ATA Security feature Set Clarifications

To: T13 Technical Committee
From: Jim Hatfield
Seagate Technology
(with Jeff Wolford: Hewlett-Packard)
389 Disc Drive
Longmont, CO 80503
Phone: 720-684-2120
Fax: 720-684-2722
Email: James.C.Hatfield@seagate.com
Date: ~~March 31~~May 24, 2006

Proposal

I propose that the following ~~text~~ be incorporated into ATA/ATAPI-8 ACS as a full replacement for the referenced sections.

Figure 1 - Security State Mode Diagram

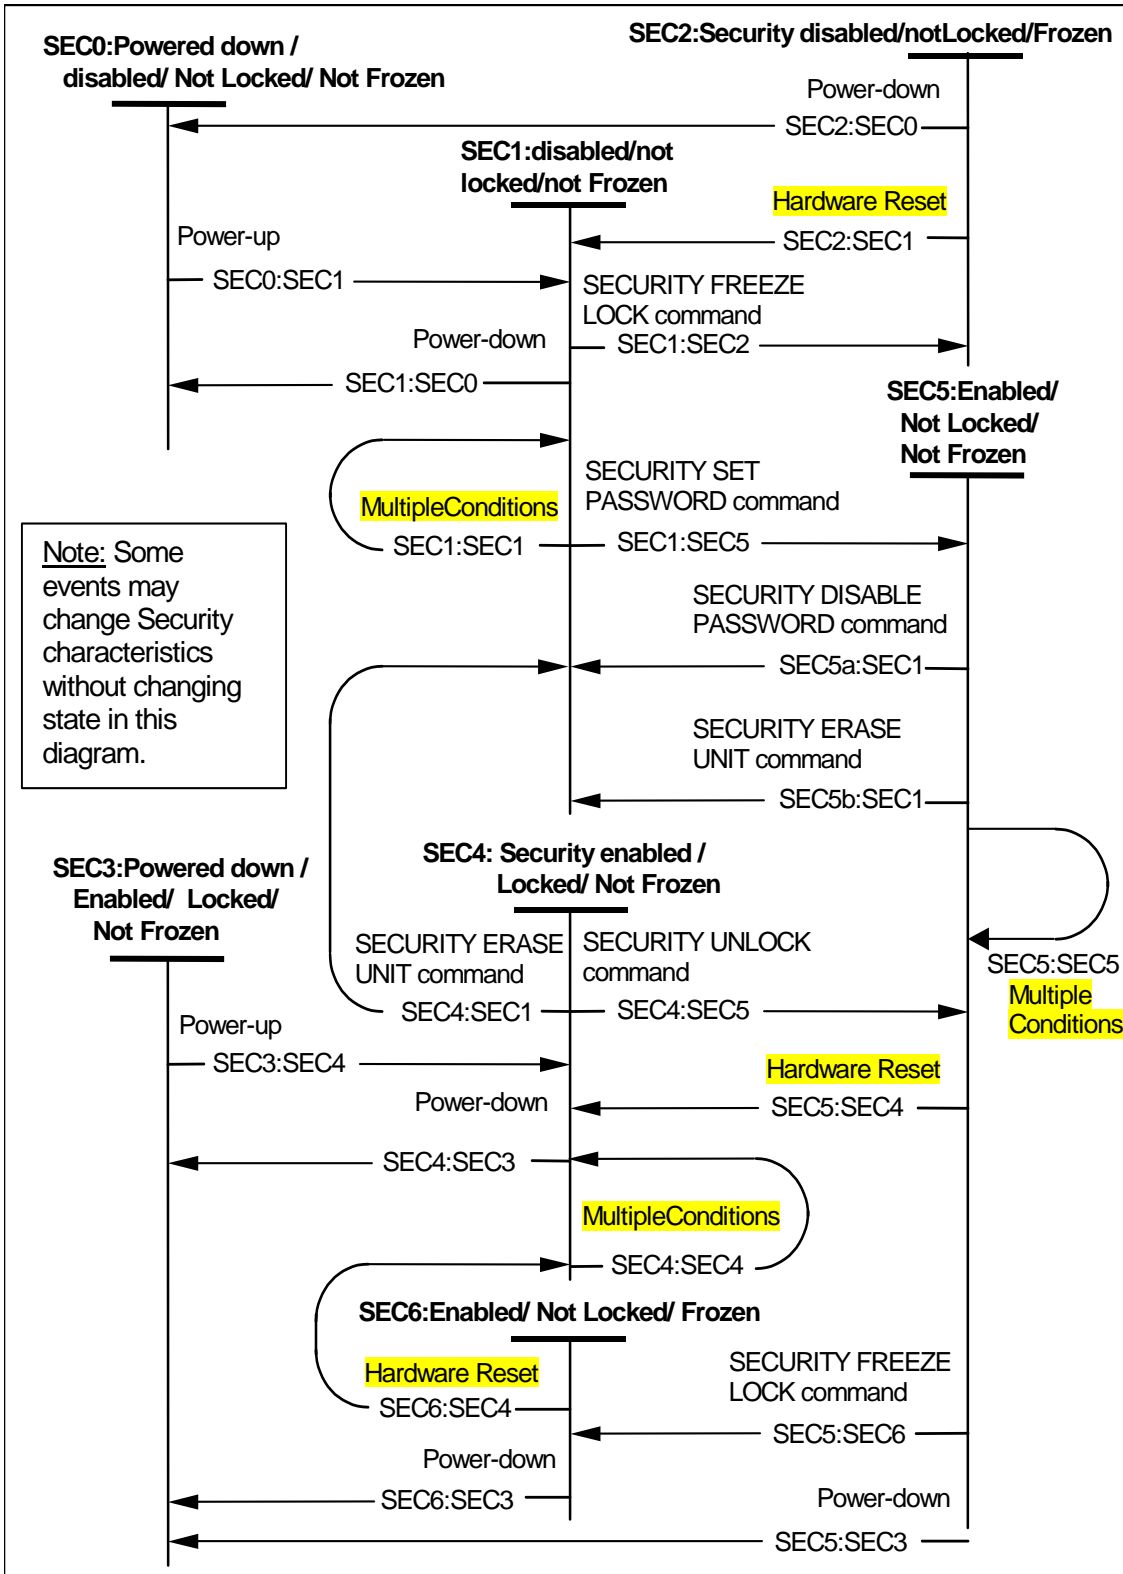
The SECURITY FREEZE LOCK command prevents changes to ~~passwords~~ all Security ~~attribute~~states until a following ~~power cycle~~ power-on reset or hardware reset. The purpose of the SECURITY FREEZE LOCK command is to prevent password setting attacks on the security system. [Editors note: fix the figure or fix this text]

[Editors note: do we need this loopback ? what about non-security commands ? is this list of events inclusive or exclusive ?] [only needed if something special is done in the state – so not needed]

[Editors note: if the loopback is kept, should it be labeled ?]

Transition SEC5:SEC5: [Editors note: do we need this loopback ? what about non-security commands ? is this list of events inclusive or exclusive ?]

Transition SEC1:SEC2: When a SECURITY FREEZE LOCK command is ~~received~~ successful, the device shall make a transition to the SEC2:~~Security disabled/Frozen~~ state.

Transition SEC1:SEC5: When a SECURITY SET (user) PASSWORD command is ~~received~~ successful, the device shall save the User password, update the Master Password Capability and make a transition to the SEC5:~~Unlocked/not frozen~~ state.

Transition SEC4:SEC5: When a ~~successful~~ SECURITY UNLOCK command is ~~received~~ successful, the device shall make a transition to the SEC5: ~~UNLOCKED/NOT FROZEN~~ state.

Transition SEC5:SEC1: When a ~~valid~~ SECURITY DISABLE PASSWORD command is successful~~received~~, the device shall make a transition to the SEC1:~~Security disabled/not Frozen~~ state.

Transition SEC5:SEC6: When a SECURITY FREEZE LOCK command is successful, the device shall make a transition to the SEC6 state.
